Date 10.13 Group **356** No. **003** Release Page 1(5)

FSB 356-003, Fog Lamp Moisture Intrusion

(October 2013)

W3047653

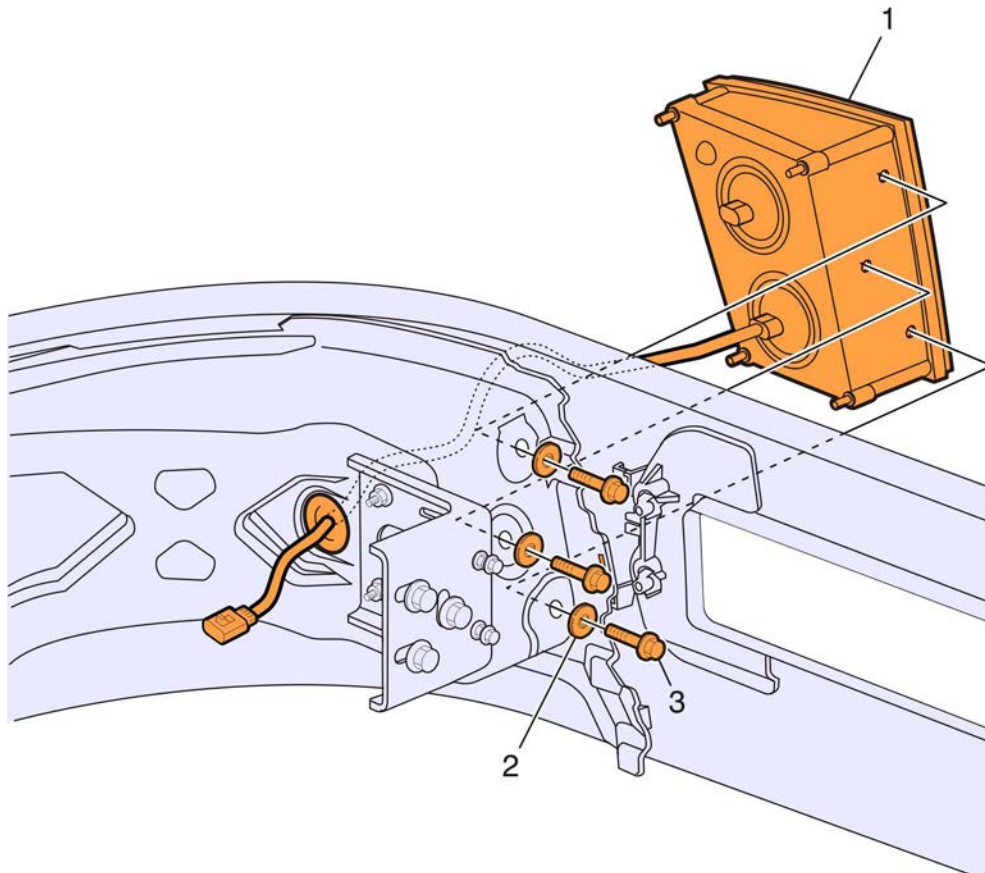
- 2 Using hand tool only, remove the three (3) mounting bolts.

Note: Do not use pneumatic or high torque electric tools this may cause the captive nuts to spin and crack the fog lamp housing.

W3047653

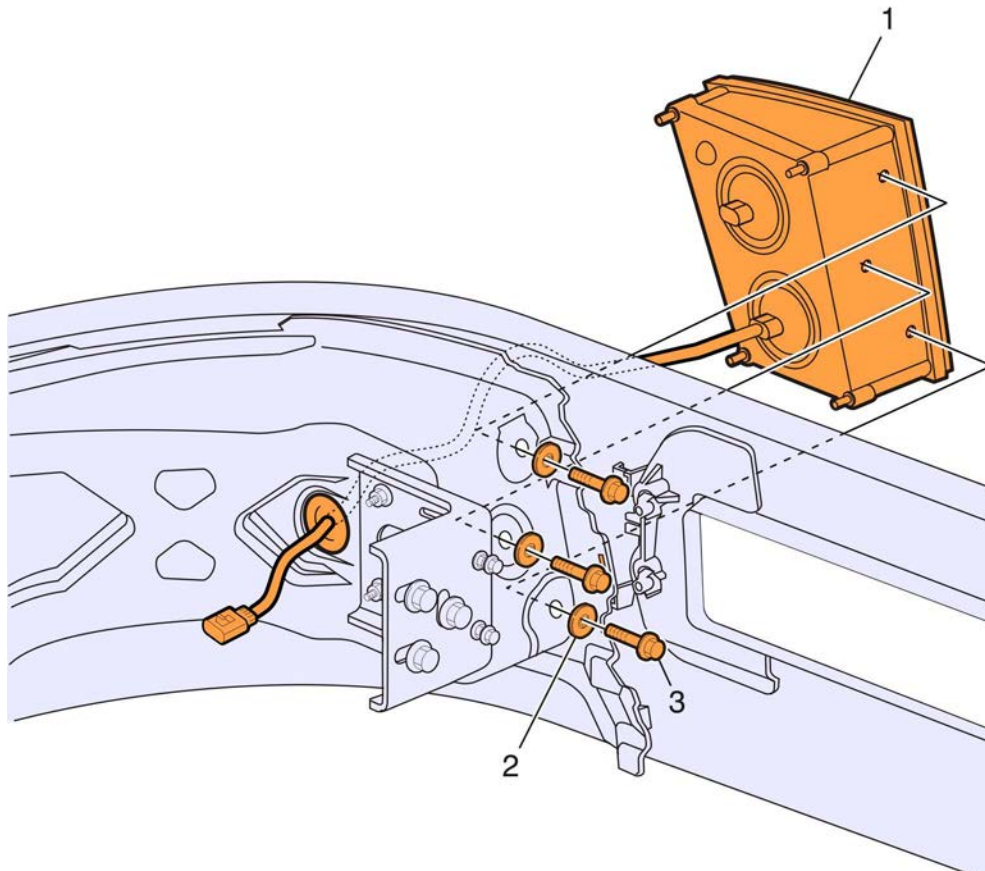
- 6 Install the bolt finger tight, then using only hand tools torque tighten to 7 Nm (5 ft-lb).
